Section 96
for Anthony Cirillio
lot 15 & 16 DP 11438
at No. 2 Carawa Rd Cromer
prepared by Arcouture

Title
Proposed Site & Roof Plan

Dwg
S96-00
Issue C

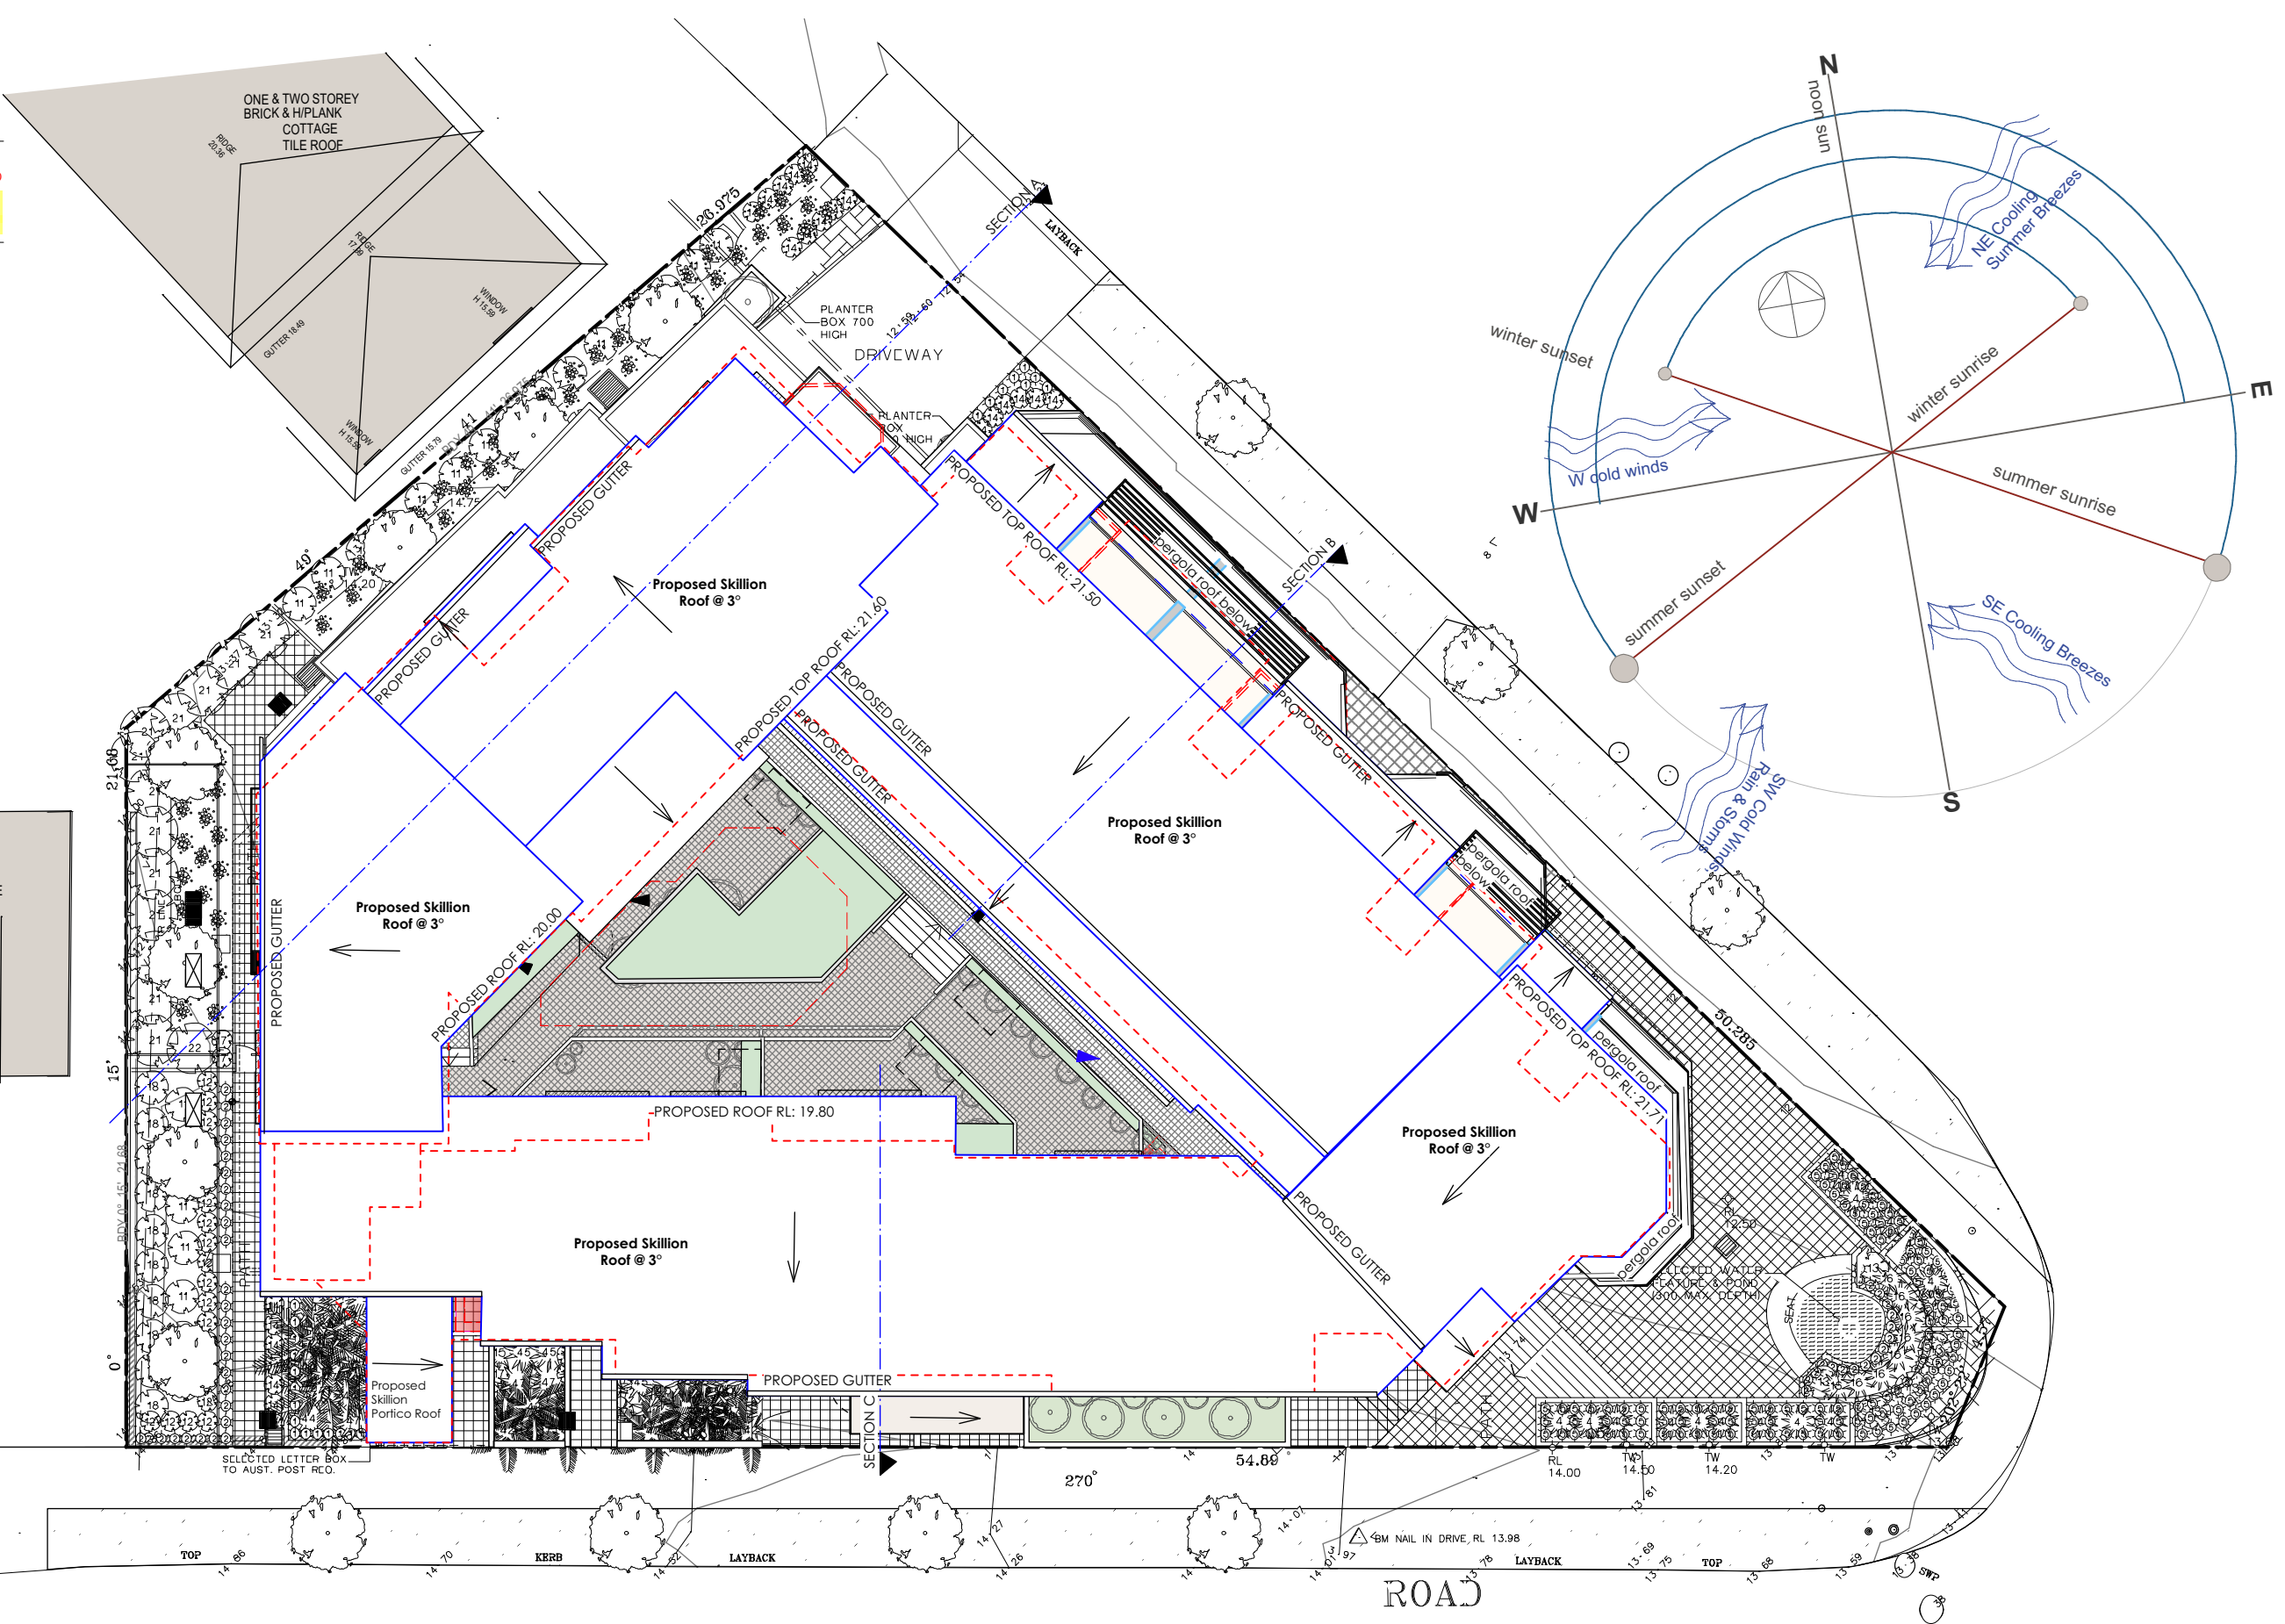
ITEMS PROPOSED
ITEMS TO BE AMENDED
Please Note: Changes to Approved DA highlighted Yellow

Title
Proposed Lower Ground Plan

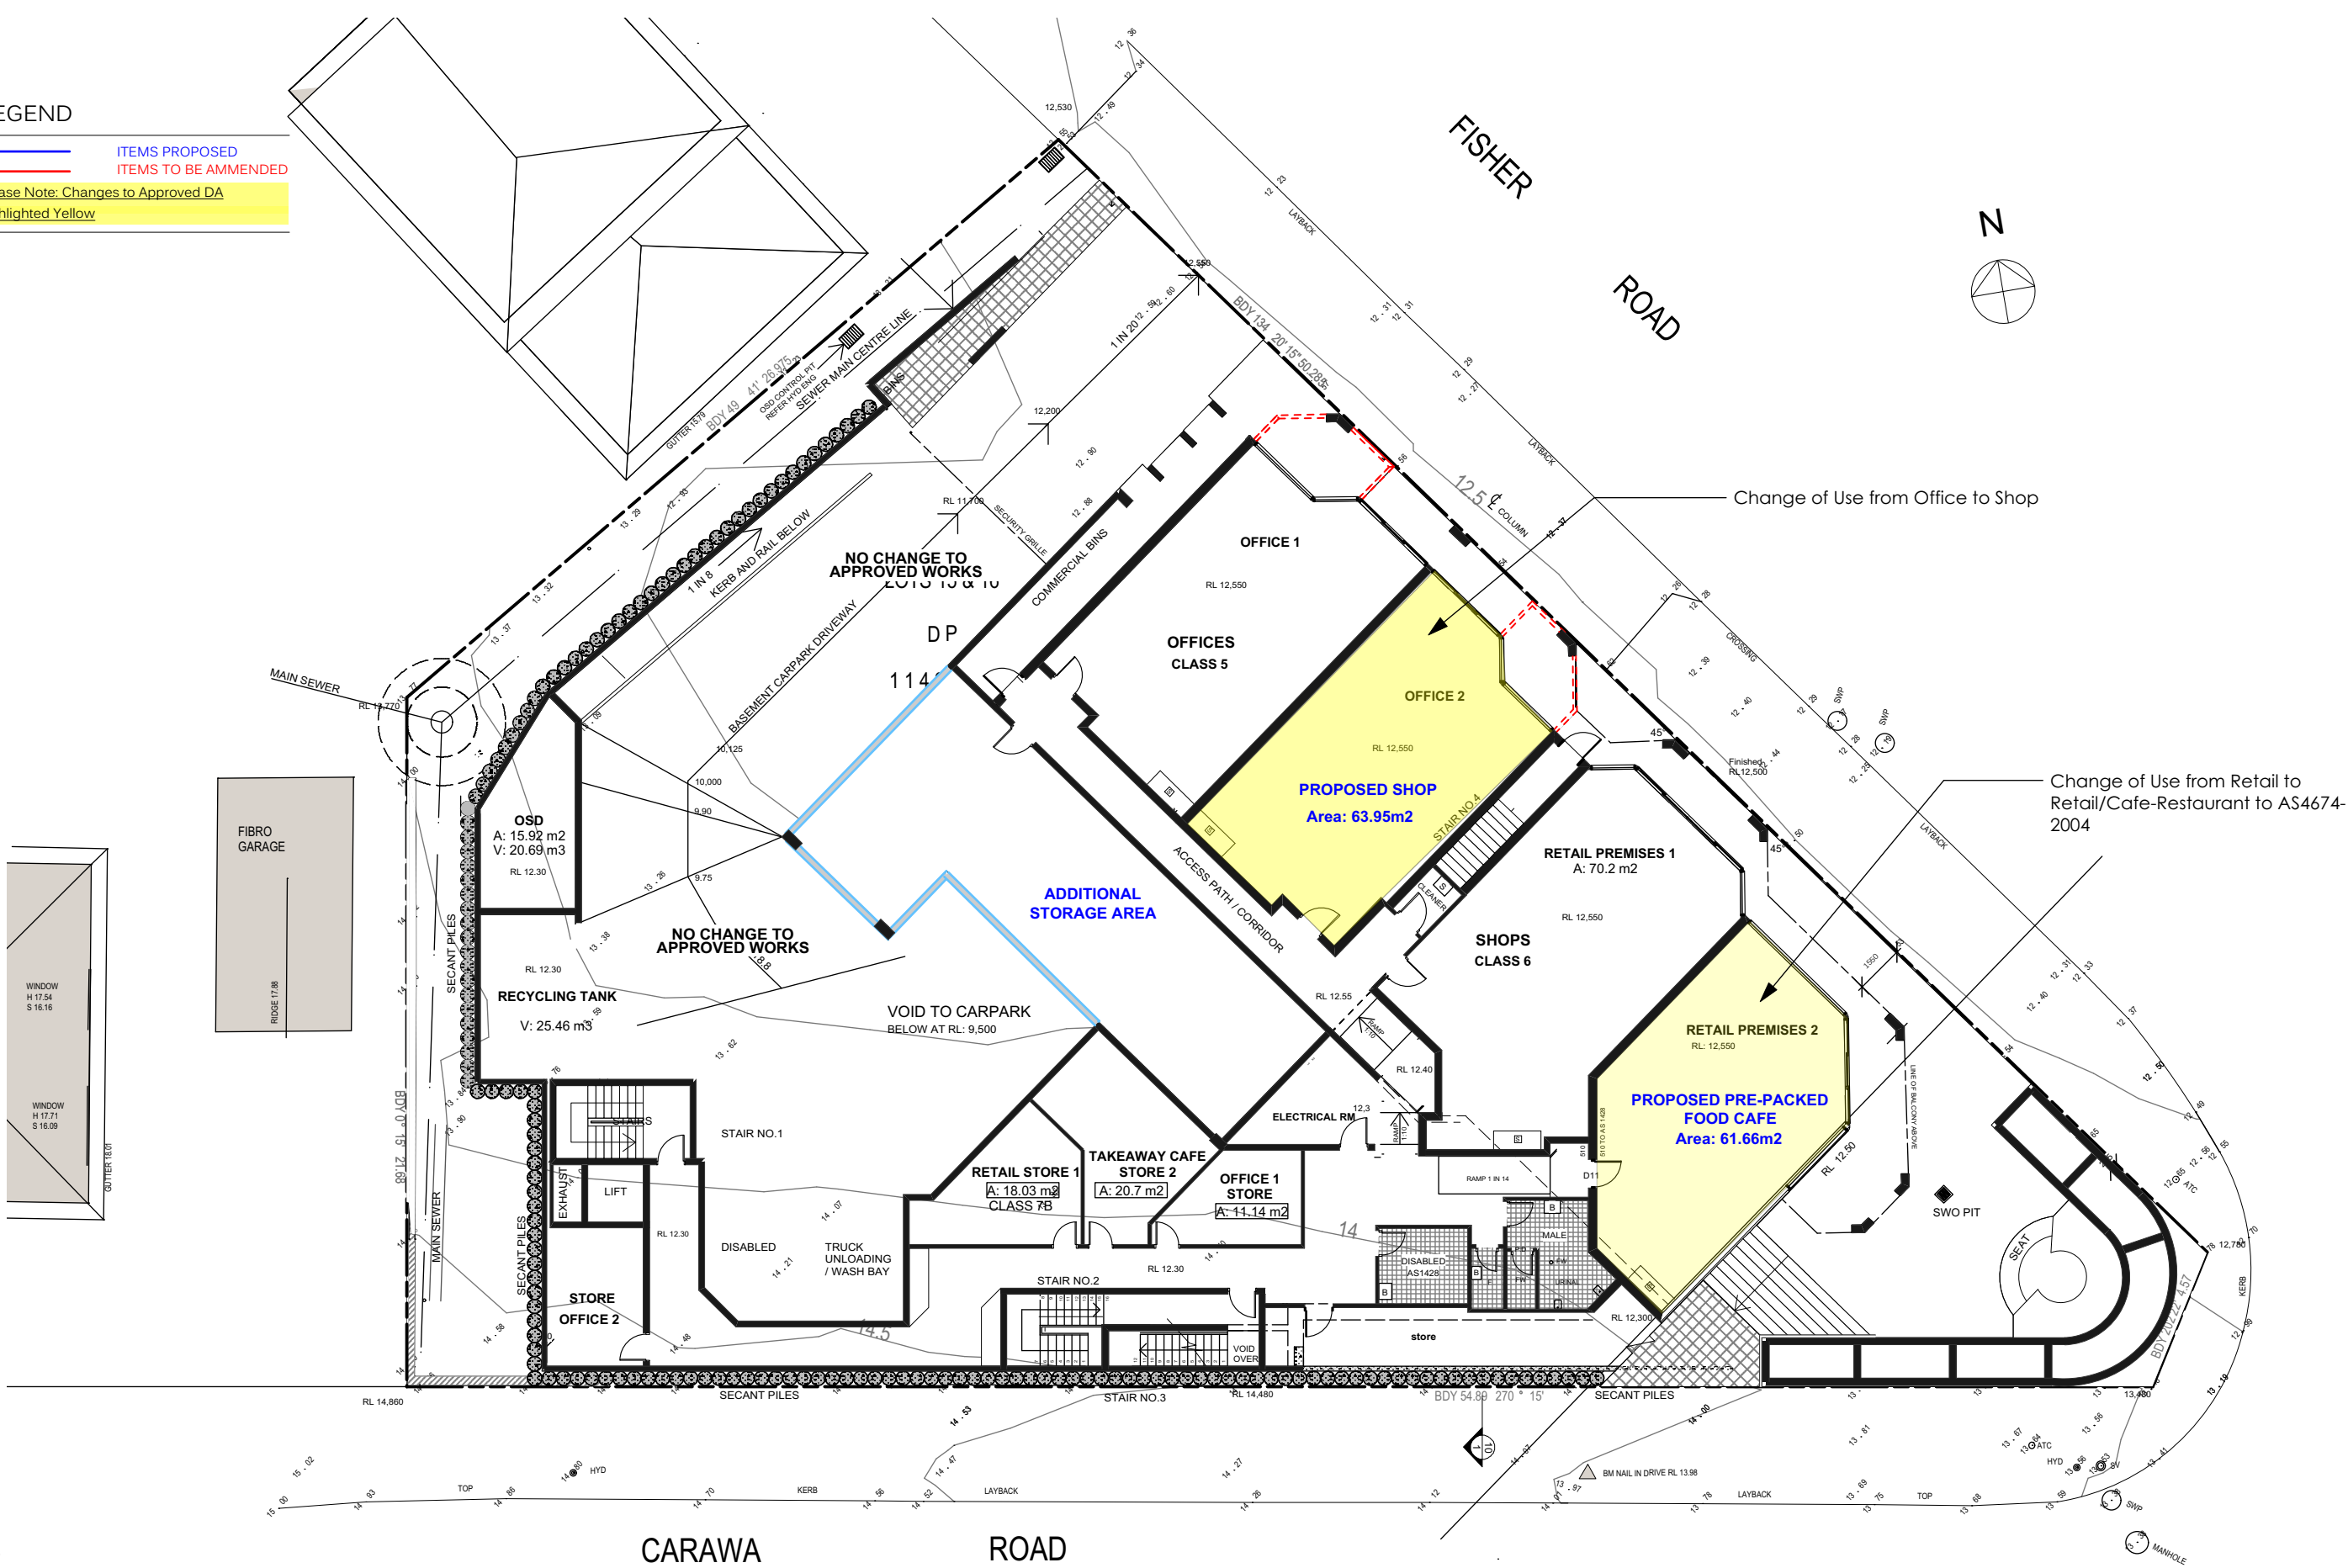
ITEMS PROPOSED
ITEMS TO BE AMENDED
Please Note: Changes to Approved DA highlighted Yellow
